Town of Parker Community Development Department
Development Review Division
Attention: **Stacey Nerger**

Application Type: **Site Plan**
Status: **First Referral**
Application Name: **Parker & Pine L3 - Slim Chickens**
Case/AP#: **SP20-058**
Referral Received: July 30, 2020
Comments Due: August 28, 2020

Review date: **August 4, 2020**
Plan reviewer: **Randall L. Capra, rcapra@parkeronline.org**
Phone: 303.805.3169

TOWN OF PARKER FIRE/LIFE SAFETY:	R REVIEWED FOR CODE COMPLIANCE; REVISIONS REQUIRED
---	---

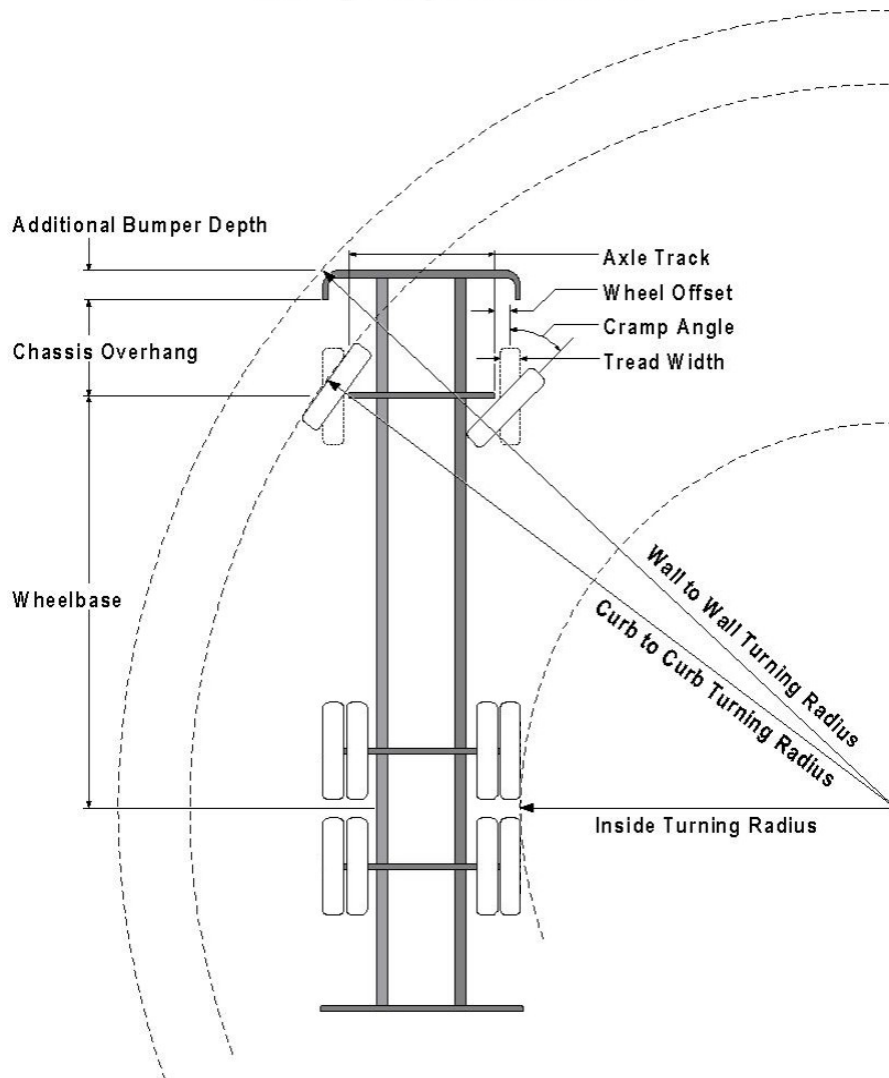
3. The applicant shall be aware that the access road hydrant distribution was not planned to address the suppression needs for all commercial properties within this subdivision; this site requires the addition of one hydrant (to be located at the s/e corner island of the building... as required per NFPA 24 Section 7.2.3... see the snap shot of the red-lined fire hydrant location shown under item 4 below:

5. As discussed in each pre-application meeting, the applicant will need to provide a *fire hydrant in the area just west of the building* (in the island in front of the entry foyer).
